**WIRELINE POLE ATTACHMENT CHARGES**

**REVIEW OF OEB DRAFT REPORT**

**NORDICITY EXPERT REPORT**

**(OEB-2015-0304)**

Table 2

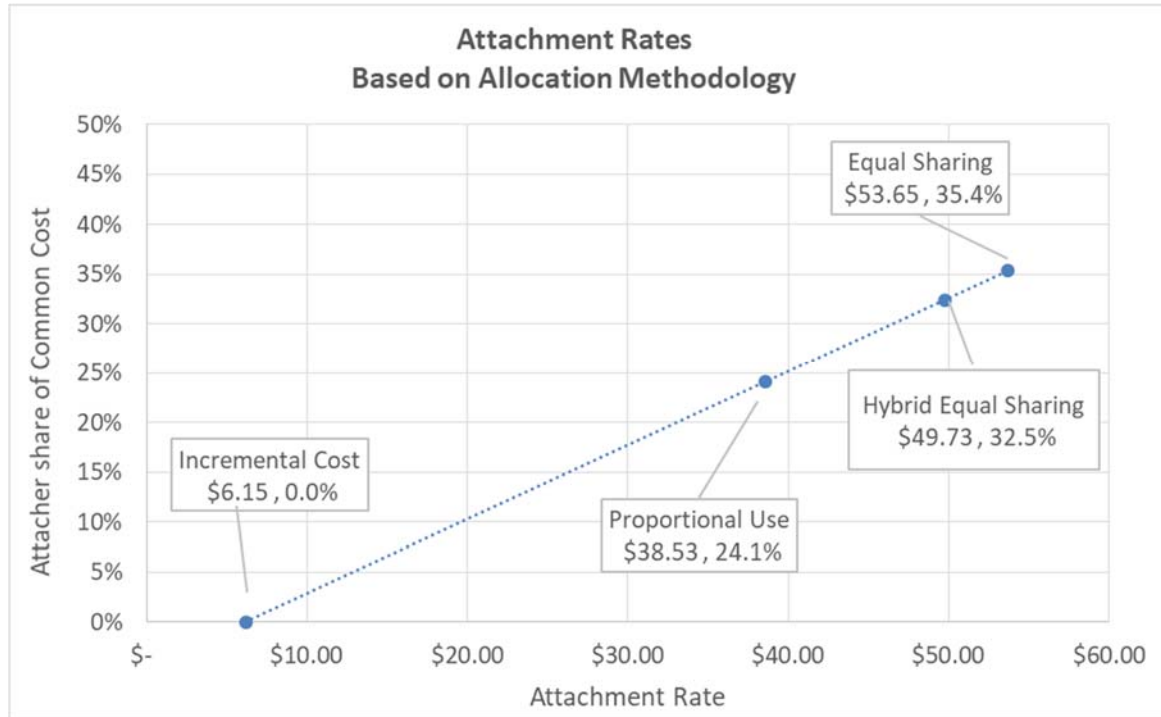
37. The “Proportional Use” methodology has been applied by other regulatory bodies in Canada, including the CRTC, Nova Scotia URB and New Brunswick EUB, while the “Equal Sharing” methodology has only been applied by the OEB and Alberta EUB.<sup>25</sup>

Table 15

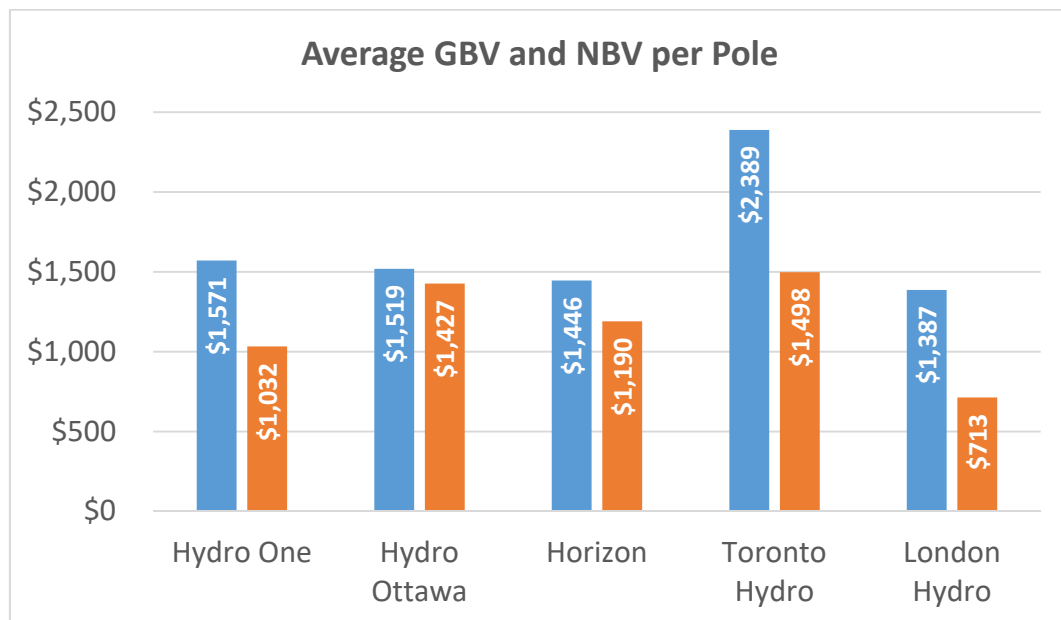
130. The table below provides a comparison of the average GBV and NBV per pole across the five included LDCs. For the average GBV per pole, the table shows a significant

variation across LDCs with Toronto Hydro reporting a GBV per pole of \$2,389 in comparison to London Hydro at \$1,387 – a difference of 70%. No explanation is provided in the Nordicity Report for this wide variance. Such a large variance raises concerns with the Toronto Hydro data that should be reviewed and addressed to understand the cause of the differences to ensure that the data is accurate and comparable, and whether any adjustments are required before the data can be used in the pole attachment rate model.

132. A review of the underlying information in Table 21 for Toronto Hydro indicates that the reported average embedded cost per pole declined from \$2,910 per pole in 2013 to \$1,511 in 2014. A significant year over year changes also occurs for Horizon between 2011 and 2012 where the average embedded cost per pole decline from \$1,634 to \$1,222. Such a large year over year change raises concerns with the quality and accuracy of the data that should be reviewed and addressed prior to using the data in the pole rate attachment model.

133. It is important to address, explain and, if necessary, adjust for or correct any anomalies such as those described above. Possible explanations could include the use of data for external financial reporting purposes versus for regulatory accounting purposes, or changes in accounting policies for capital assets by LDCs. Understanding the reasons for the anomalies would then permit an assessment of whether any adjustment is necessary for using the data in the pole rate attachment model.

Table 17

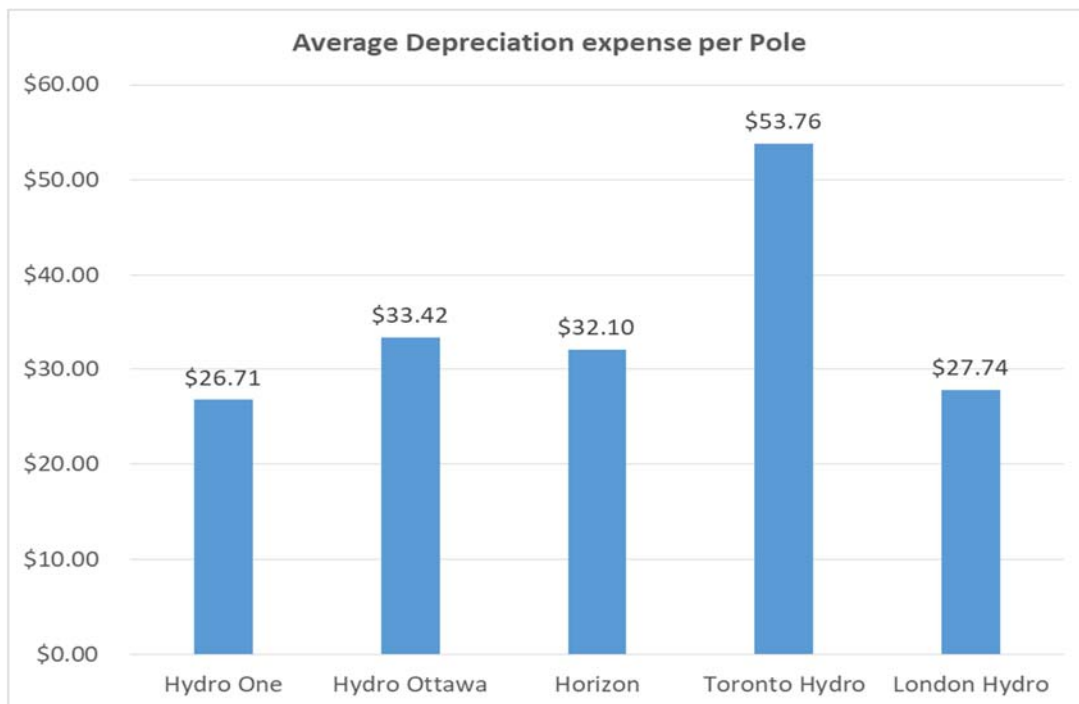
135. The table below provides a comparison of the average annual depreciation expense per pole for each of the five LDCs. These costs are impacted by both the GBV per pole, as well as the depreciation rate (%) for each LDC. Concerns regarding the differences in the GBV for Toronto Hydro in comparison to the other LDCs are addressed above.

136. The depreciation rates for 2010-2015 from Nordicity Report Table 22 are provided below. As the table below illustrates, the Cost Breakdown Appendix uses a simple average of the annual depreciation rates for each LDCs.<sup>72</sup> The simple average for three LDCs - Hydro Ottawa, Horizon and London Hydro, is significantly impacted by a change

to the useful lives applicable to poles. For 2010 and 2011, these three LDCs applied a depreciation rate of 4%, or 25 years. In 2013, the useful life was revised to between 2.00% - 2.22%, or 45.5 – 50 years. These changes in the LDCs' useful life for poles were also noted by Nordicity.<sup>73</sup>

137. Using a simple average that includes the two years with the useful lives that are no longer applicable embeds the impact of these changes to useful lives into the pole attachment rate model. As these outdated lives are not reflective of the current useful lives of poles, it would be more appropriate to remove the impact of the change in useful lives for the LDCs. One approach would be to use the 2015 depreciation rates, as these are reflective of the current useful lives. Alternatively, the average depreciation rates could be re-calculated without the 2010 and 2011 depreciation rates, to remove the impact of the change in useful lives.

Table 21

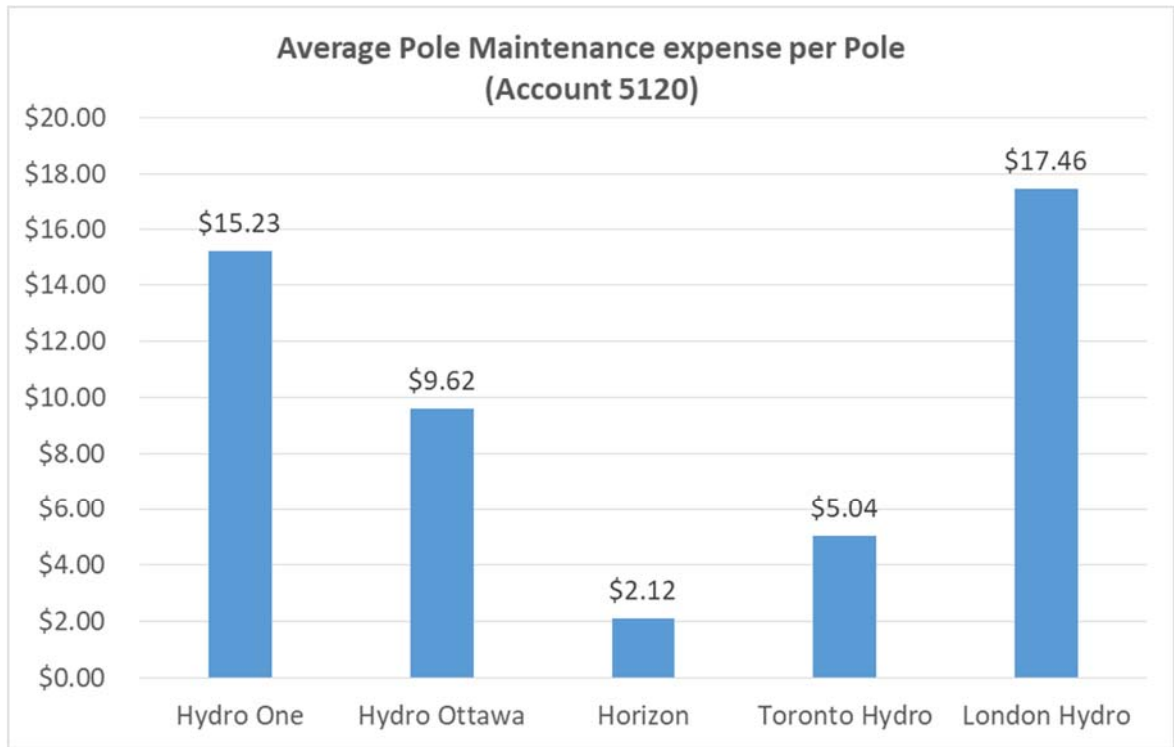
ranges considerable among LDCs, from a low of \$2.12 for Horizon to a high of \$17.46 for London Hydro, 725% higher than Horizon.

151. The OEB Draft Report does not address the wide range in cost across LDCs.
